BACK RIVER PROJECT
Responses to 2021 Annual Report Comments

August 5, 2022

Responses to 2021 Annual Report Comments

Figure 7.1-3: Incidental Marine Mammal Observations During Shipping, August and September 2021

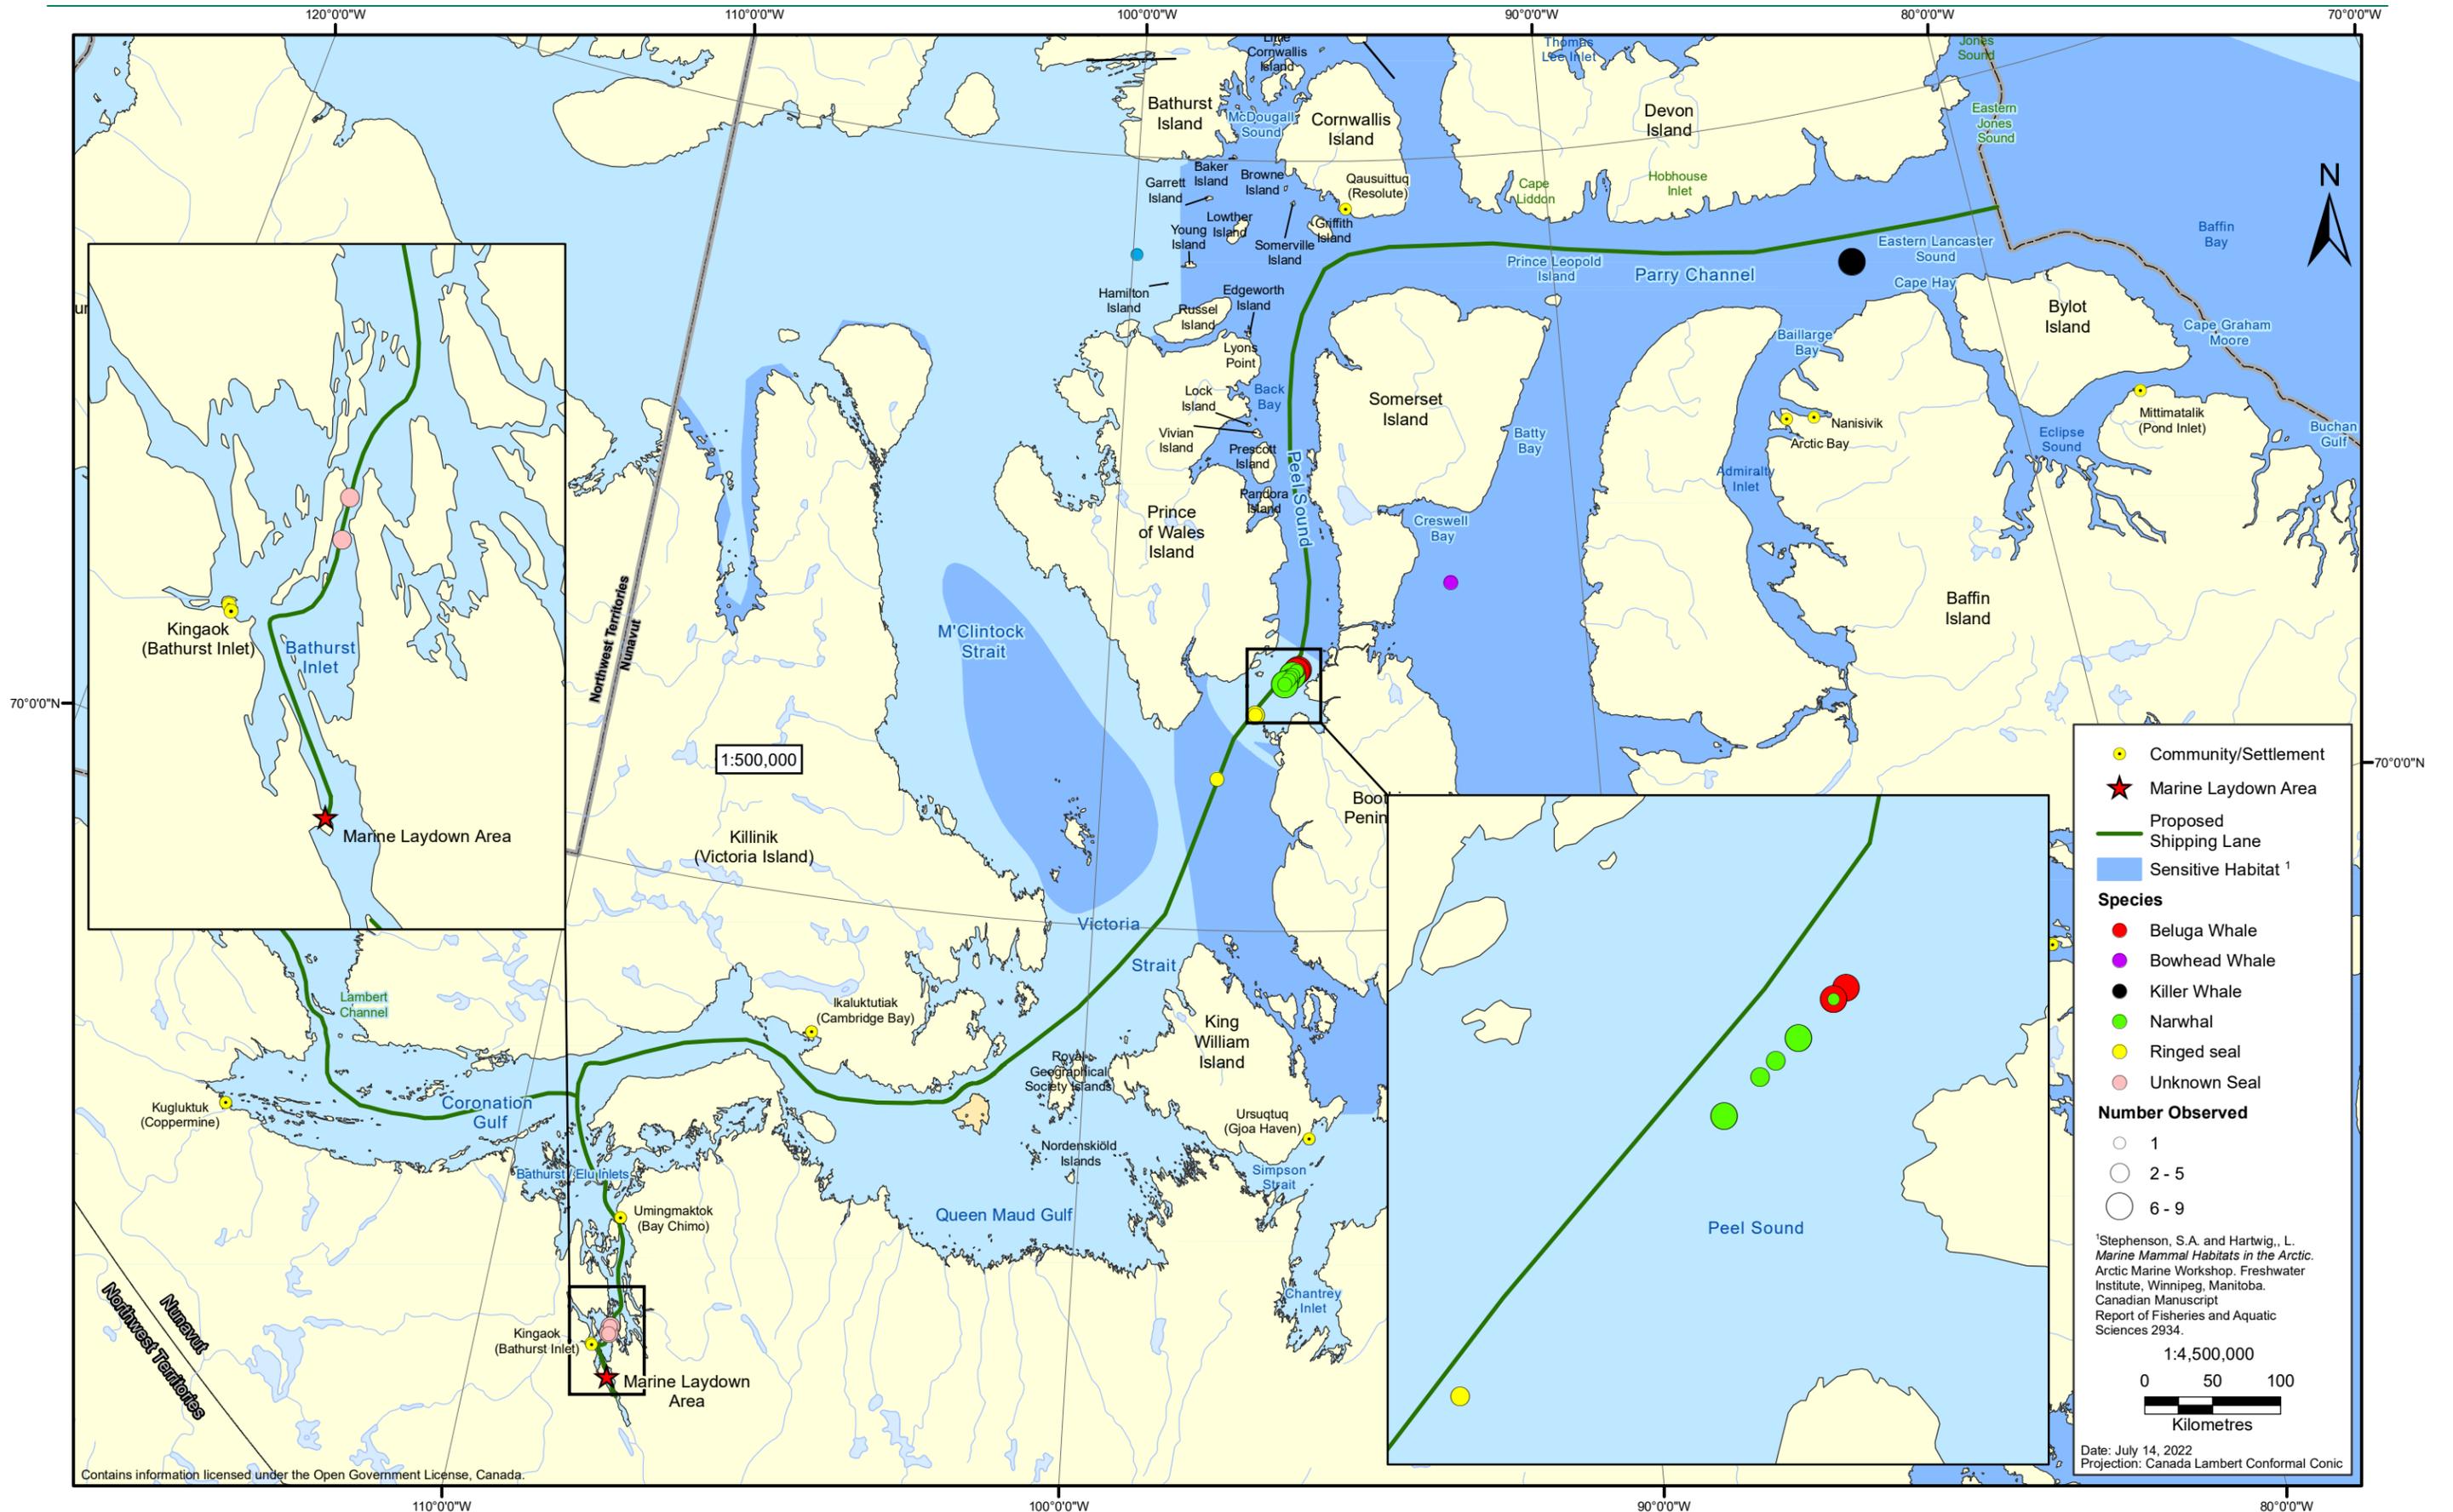
Table 7.1-2 and Figure 7.1-3 in the 2021 Pre-Construction WMMP Report present the incidental observations of marine mammals recorded during shipping activities in 2021 (for which marine wildlife monitoring was conducted; see the KIA's critique in review comment KIA-NIRB-09). In Table 7.1-2, Sabina indicates that a bowhead whale was observed swimming 250 m from the vessel. However, the bowhead whale observation on Figure 7.1-3 is located west of Young Island, over 100 km away from the proposed shipping line.

- Please clarify whether the coordinates for the bowhead whale observation are inaccurate (and if corrective actions need to/have been taken) or if the ship went off course from the proposed shipping route (and why).
- Please add the missing incidental bird observation data to the map Figure 7.1-4. If location data are not available, please explain why the data are missing, and ensure that locations are collected during future marine seabird monitoring surveys.

- The locations of observations are those provided by the vessels. Sabina provides a Marine Shipping – Wildlife Mitigation and Monitoring SOP to shipping companies and they provide the SOP to ship captains. The SOP includes a “Proposed shipping lane” that takes in to account setbacks from wildlife sites and shows where a route passes through Key Habitat Sites, such as Eastern Lancaster Sound. The vessel captain is responsible for the safe operation of the ship and can alter the vessels course in response to weather, sea conditions ice, and other factors. On the return voyage from Bathurst Inlet, one of the vessels took the passage between the Boothia Peninsula and Somerset Island rather than transiting all of Peel Sound. Alternate routes are taken at the captain’s discretion for the safe operation of the vessel and as long as they meet the requirements of the WMMP and Marine Shipping SOP, such as setbacks from Key Habitat Sites. Future versions of the annual WMMP Report will include a vessel track, where these data are available.

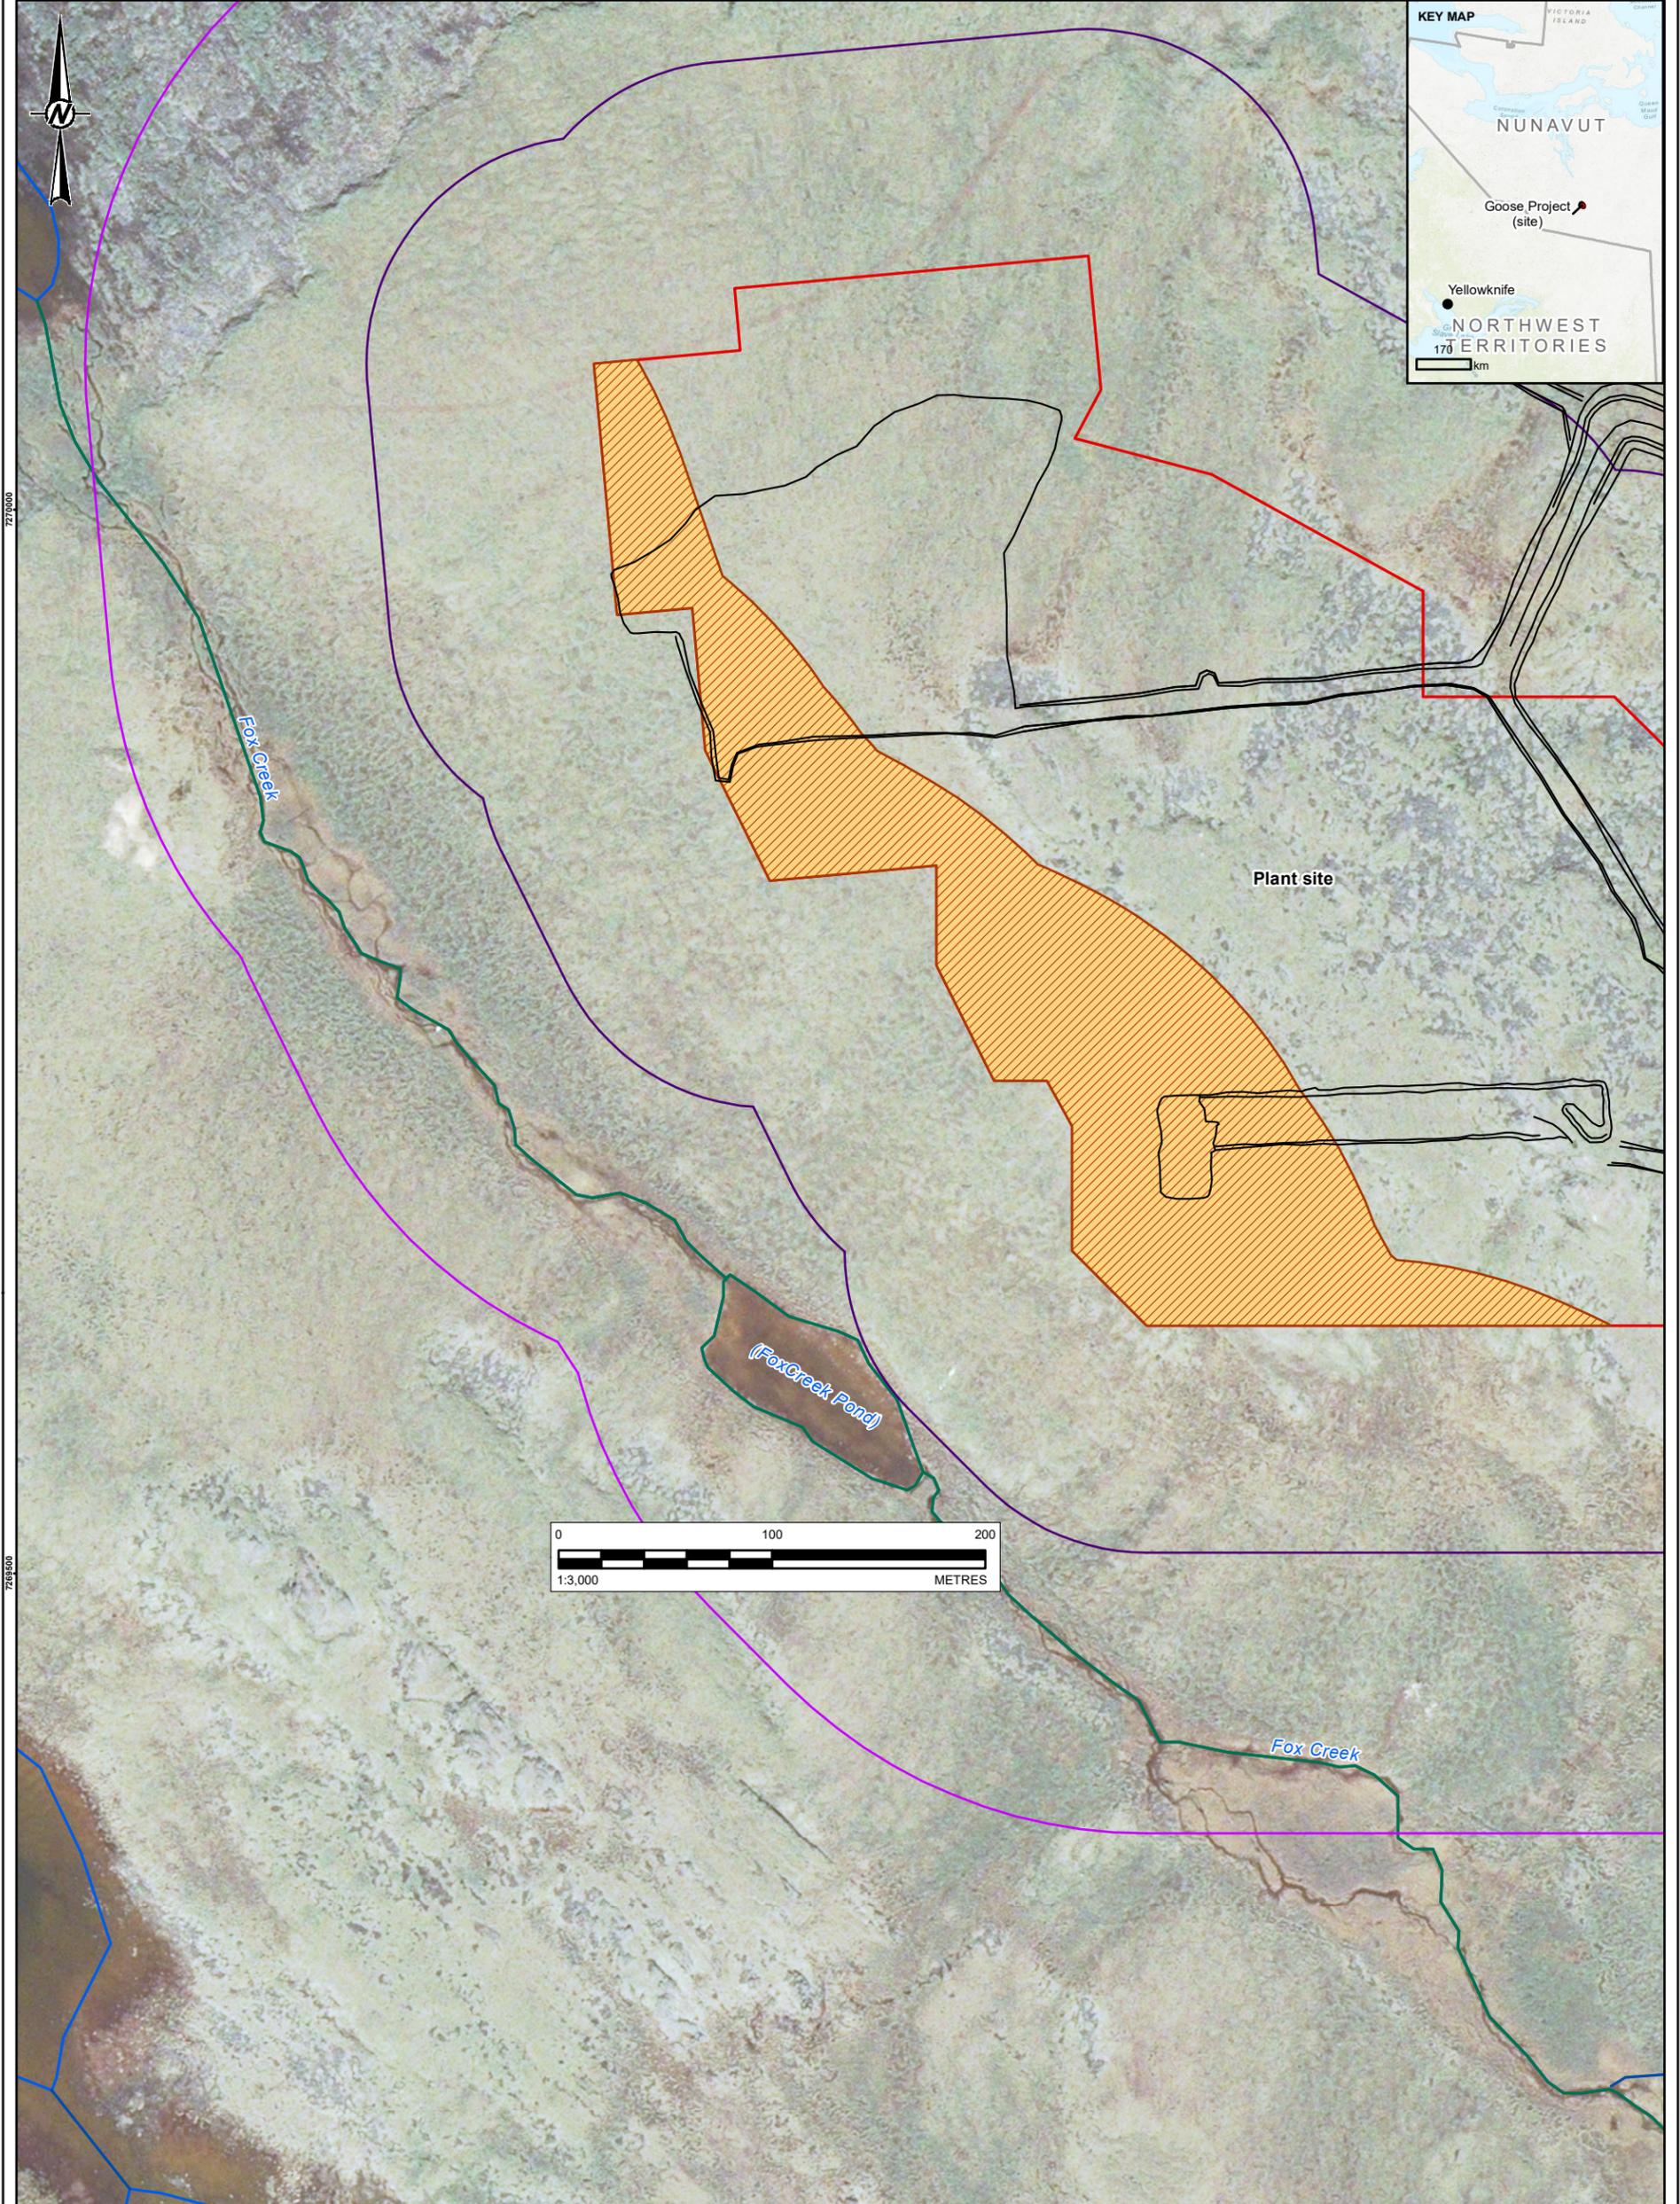
Overwintering habitat of Fox Creek and any small ponds within the Fox Creek system

Confirm presence or absence of overwintering habitat in the Fox Creek system.
